**Response to
Request for Additional Information No. 6, Revision 0
6/05/2008**

U. S. EPR Standard Design Certification

AREVA NP Inc.

Docket No. 52-020

Figure 19-85-1—Pool Scrubbing Data for Downcomer Venting

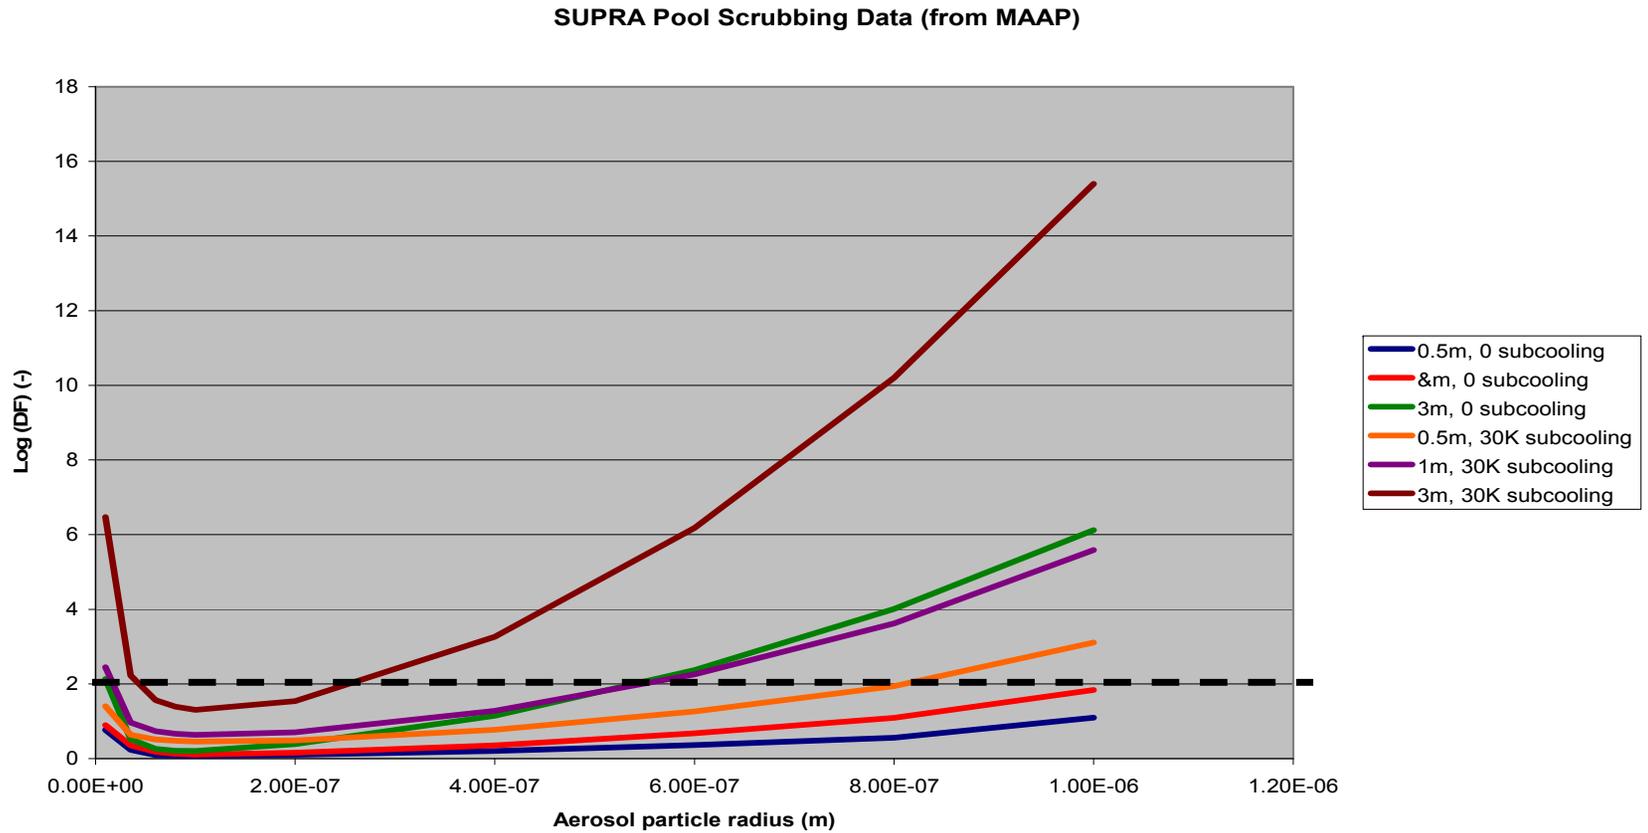
Please provide the analysis of the scrubbing of releases in the steam generator for release categories 701 and 702.

Figure 19-85-1 shows the results for “downcomer” injection mode, and various of the other parameters. If the 3m deep pool with zero subcooling is used, a wide range of DF is apparent, with all particle sizes larger than 0.3 – 0.4 micron radius experiencing $DF > 20$. In order to have an idea of the aerosol size distribution, Figure 19-85-4 was used (distribution with aerosol source taken since it has more small particles which have lower DFs). To read this plot, the non-dimensional particle size parameter VR has to be converted back to a radius in meters (refer to Table 19-85-4). This was done using the data shown in Table 19-85-3 with the result shown in Table 19-85-5. It can be seen that at about a 0.5 micron radius, the value of VR is 1.0. Comparing now with the size distribution shown in Figure 19-85-4, it is clear that a large fraction of the aerosol mass will be in the form of particles with $DF > 20$. On this basis, for the conditions assumed, the value of 20 was selected.
